Request for Class II Permissive Change(C2PC)

FCC ID: VG8XM0P04YY

Date: 2023-11-08

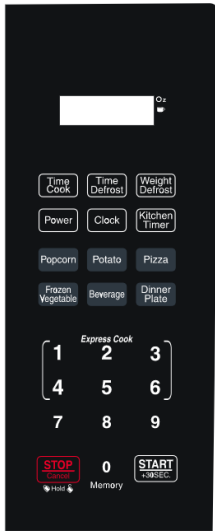
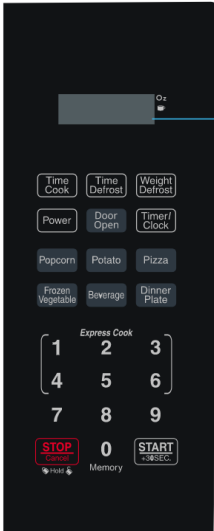
No.:	Original	New	Difference(s)
1			Keypad: Updated front keypad to accommodate child lock function (Child resistant oven door function)
2			Mother board: Modified the peripheral circuit (non-RF circuit) and some individual components and PCB layout. The magnetron and other circuit are exactly same as before
